APPROVED

By Tim Askin - Milwaukee HPC at 1:42 pm, Nov 05, 2021

1000 W MITCHELL FACADE REPAIRS DESIGN DESIGN DRAWINGS

1000 W HISTORIC MITCHELL ST MILWAUKEE, WI 53204

A100

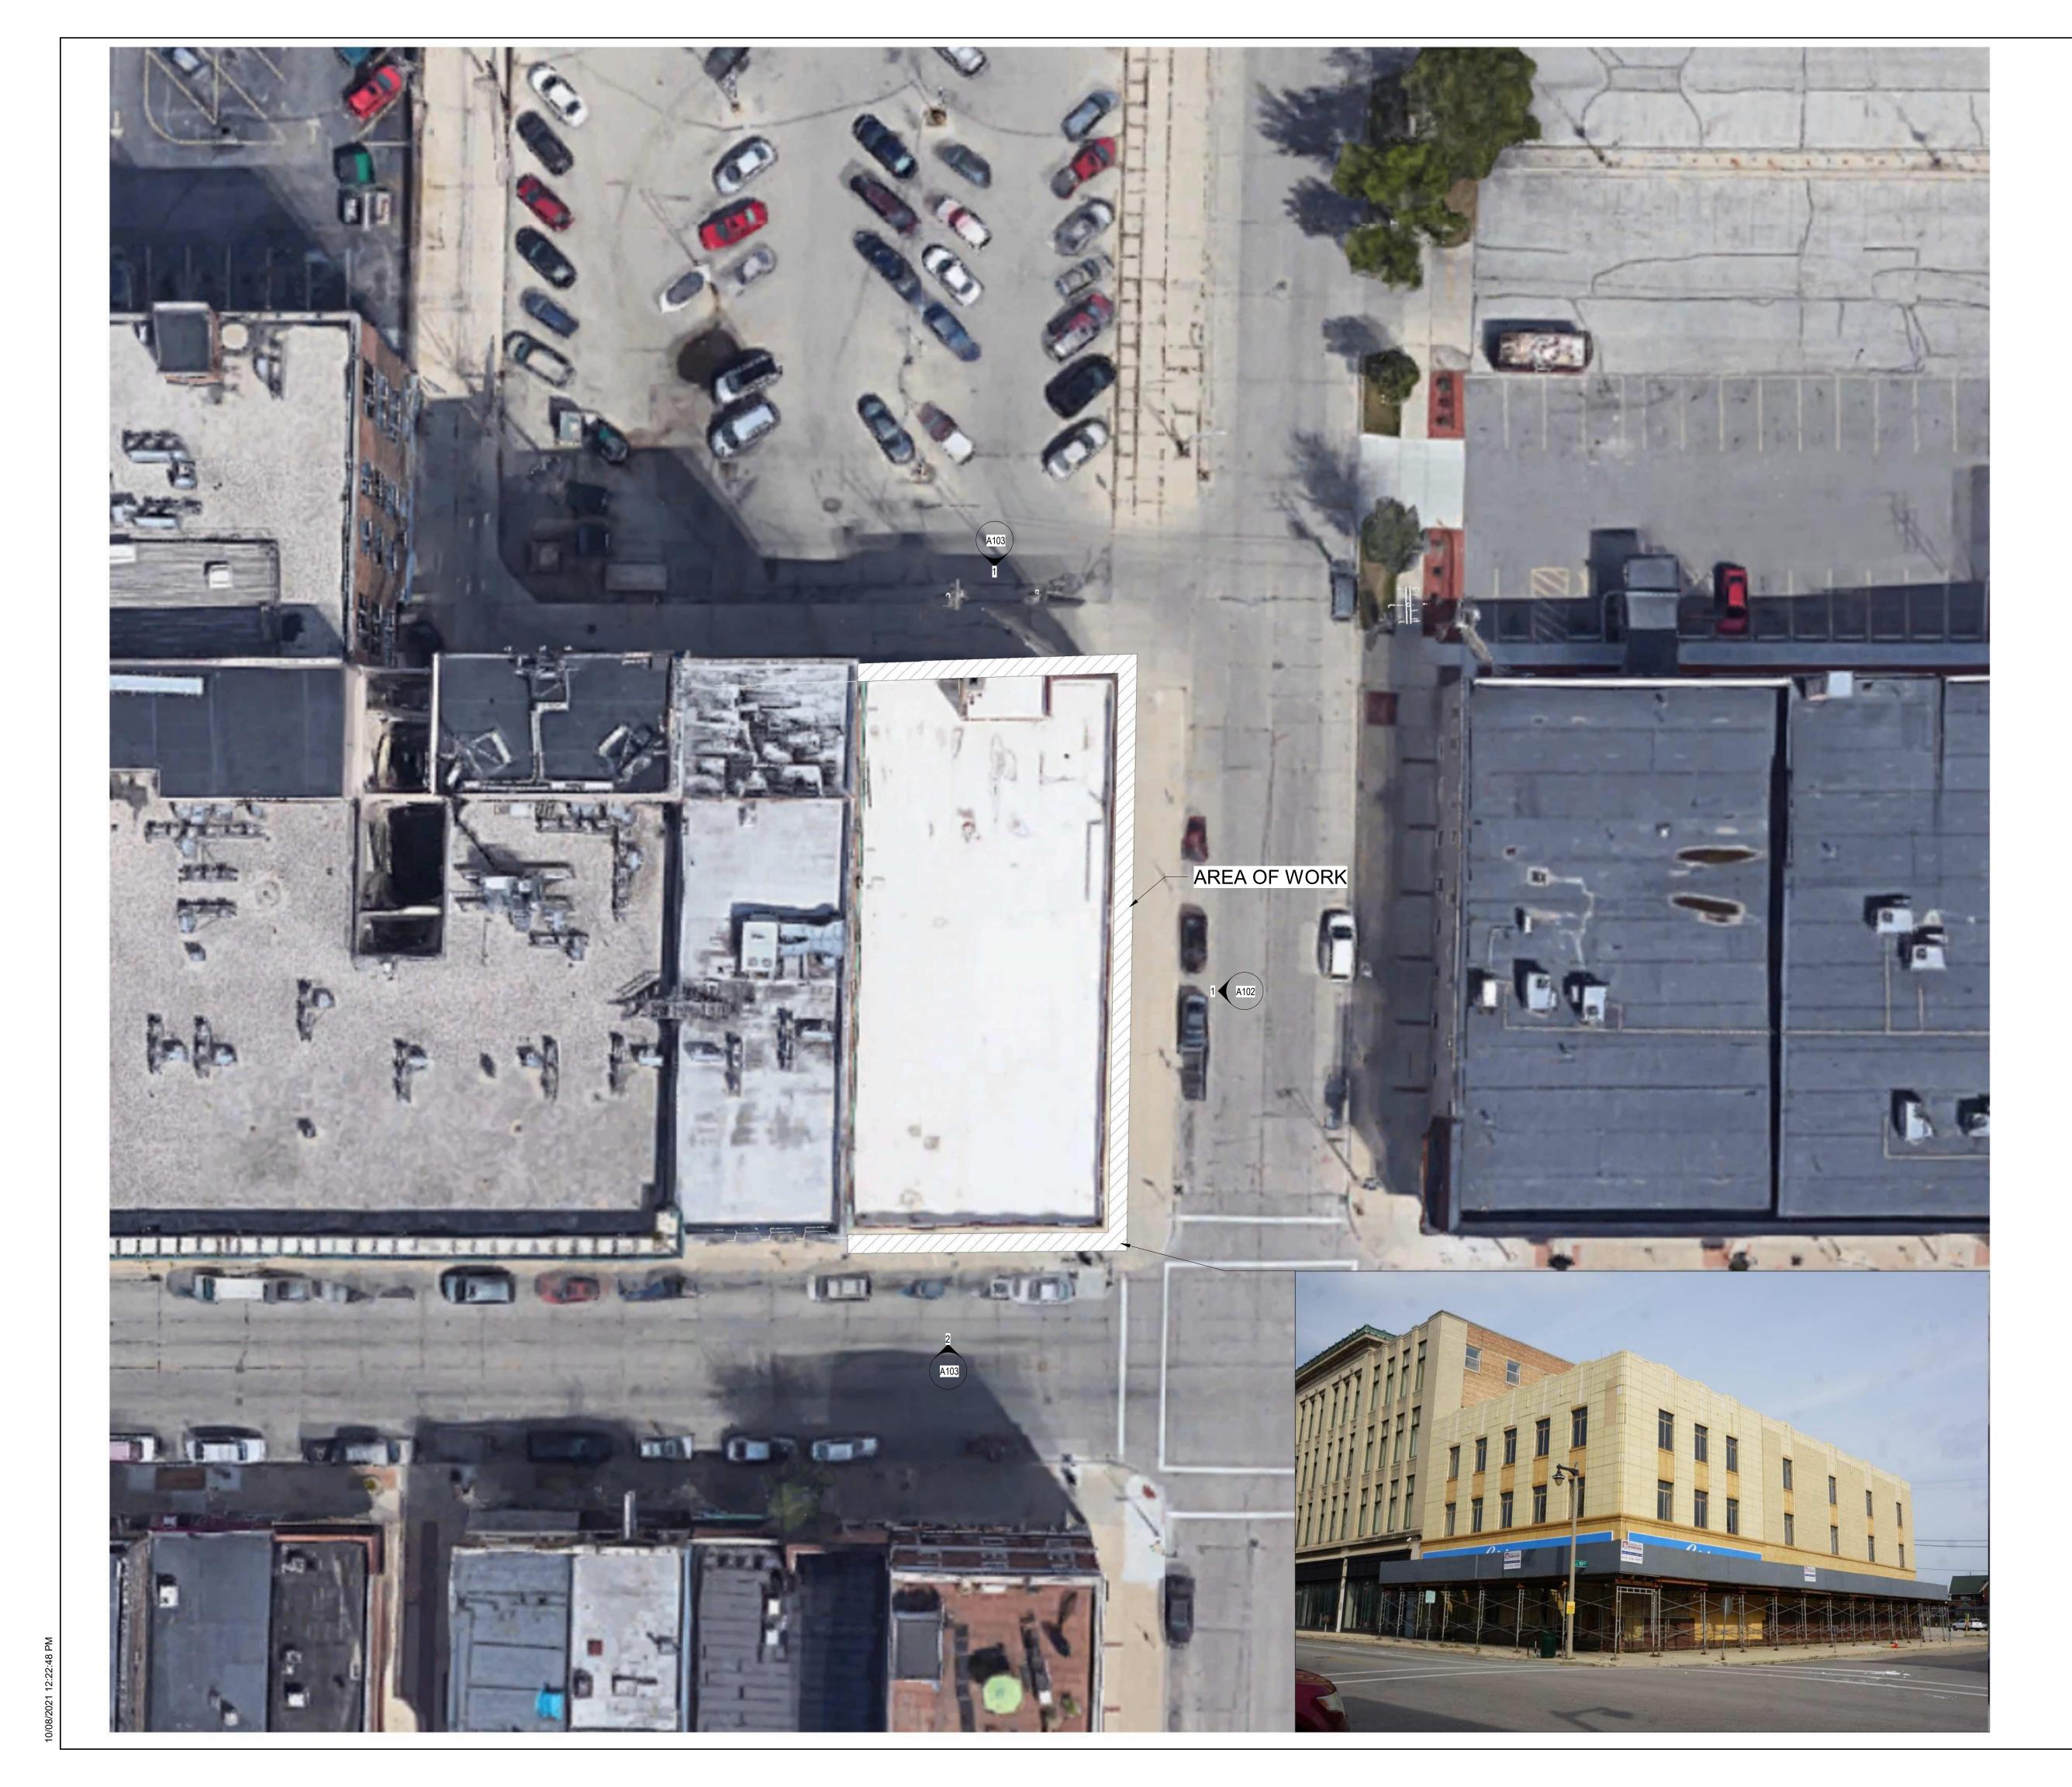
New mortar must match the original mortar in terms of color, texture, grain size, joint width, and joint finish/profile. The compressive strength of the repointing mortar shall be equal or less than the compressive strength of the original mortar and surrounding brick or stone. The replacement mortar shall contain approximately the same ingredient proportions of the original mortar. Mortar that is too hard is subject to premature failure and could damage the masonry. See the city's books As Good As New or Good for Business, Masonry Chapters, for more information. In most cases, this means a lime mortar with natural hydraulic cement rather than Portland cement. No joint of a width less than 3/8" may be cleaned of damaged/decomposed mortar with power disc grinders. No overcutting of the joints is permitted. Remove decomposed mortar back into the wall 2.5 times the height of the joint before repointing. When installing new flashing at a masonry feature, the flashing must be stepped or cut into the mortar joints. The bricks may not be cut to install flashing at an angle.

New brick must match as closely as possible the color texture, size, and finish of the original brick. A sample panel of brick and mortar must be reviewed and approved by HPC staff prior to general installation of the material.

UNDER NO CIRCUMSTANCES SHALL UNPAINTED MASONRY BE PAINTED, BE GIVEN A WATERPROOFING TREATMENT, OR CLEANED BY ABRASIVE MEANS; THIS STATEMENT SUPERSEDES ANY OTHER WORDING IN THIS DOCUMENT INDICATING THE CONTRARY. **Masonry Cleaning**

Abrasive cleaning methods are prohibited on historic buildings by Wisconsin state law. Exceptions can only be granted in writing by the Wisconsin Historical Society. Chemical and power-washing are acceptable methods of cleaning that the city can approve. Pressure at the nozzle is not to exceed 800psi, 400-600psi is usually adequate for cleaning, though it may take more time and more passes than higher pressures.

Pressure washing of historic buildings is limited by state law and known best practices. Pressure washing is to be conducted ONLY with fan tips with a spread of 15-50 degrees, maximum 800psi at the tip, flow rate less than 8gpm, and from a distance from the surface of a minimum of 12" inches

A102

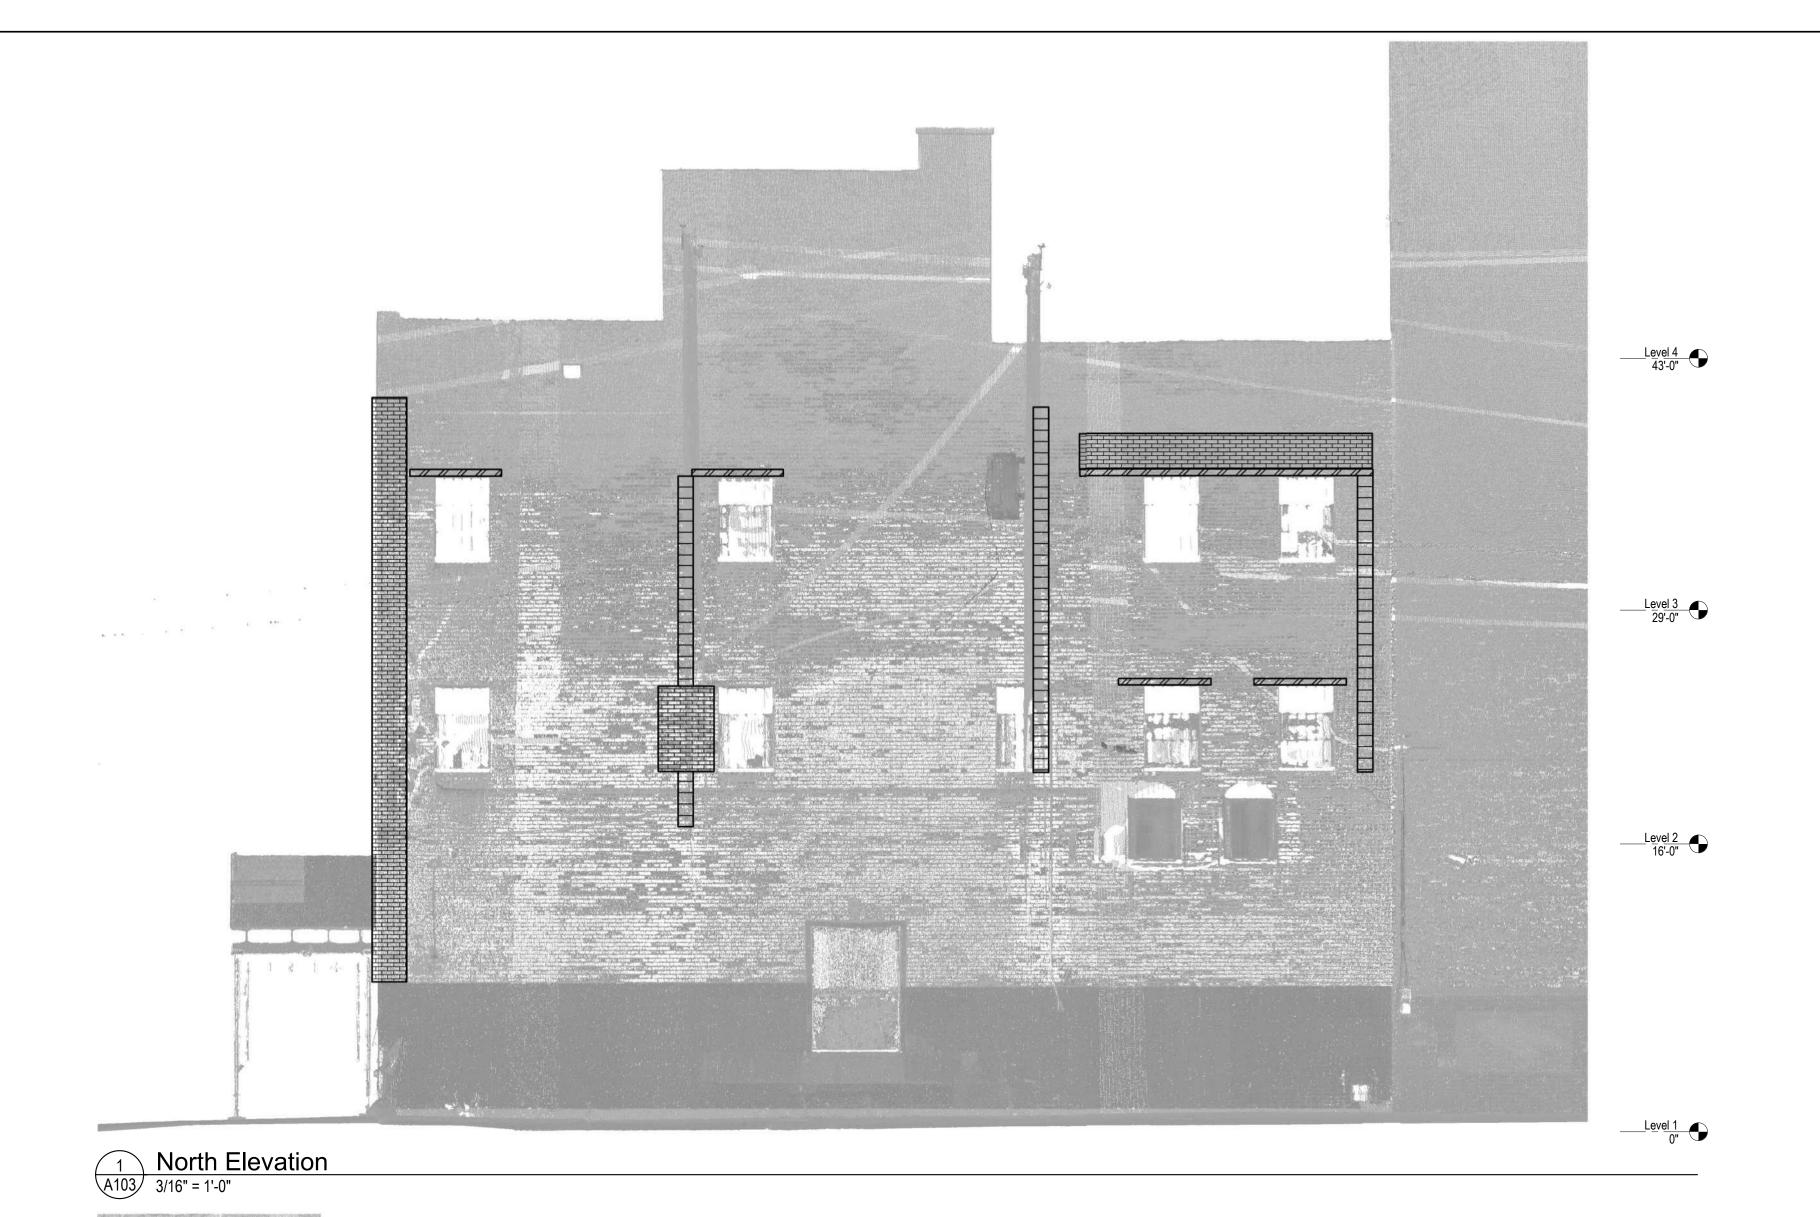
New mortar must match the original mortar in terms of color, texture, grain size, joint width, and joint finish/profile. The compressive strength of the repointing mortar shall be equal or less than the compressive strength of the original mortar and surrounding brick or stone. The replacement mortar shall contain approximately the same ingredient proportions of the original mortar. Mortar that is too hard is subject to premature failure and could damage the masonry. See the city's books As Good As New or Good for Business, Masonry Chapters, for more information. In most cases, this means a lime mortar with natural hydraulic cement rather than Portland cement. No joint of a width less than 3/8" may be cleaned of damaged/decomposed mortar with power disc grinders. No overcutting of the joints is permitted. Remove decomposed mortar back into the wall 2.5 times the height of the joint before repointing. When installing new flashing at a masonry feature, the flashing must be stepped or cut into the mortar joints. The bricks may not be cut to install flashing at an angle.

New brick must match as closely as possible the color texture, size, and finish of the original brick. A sample panel of brick and mortar must be reviewed and approved by HPC staff prior to general installation of the

UNDER NO CIRCUMSTANCES SHALL UNPAINTED MASONRY BE PAINTED, BE GIVEN A WATERPROOFING TREATMENT, OR CLEANED BY ABRASIVE MEANS; THIS STATEMENT SUPERSEDES ANY OTHER WORDING IN THIS DOCUMENT INDICATING THE CONTRARY. **Masonry Cleaning**

Abrasive cleaning methods are prohibited on historic buildings by Wisconsin state law. Exceptions can only be granted in writing by the Wisconsin Historical Society. Chemical and power-washing are acceptable methods of cleaning that the city can approve. Pressure at the nozzle is not to exceed 800psi, 400-600psi is usually adequate for cleaning, though it may take more time and more passes than higher pressures.

Pressure washing of historic buildings is limited by state law and known best practices. Pressure washing is to be conducted ONLY with fan tips with a spread of 15-50 degrees, maximum 800psi at the tip, flow rate less than 8gpm, and from a distance from the surface of a minimum of 12" inches
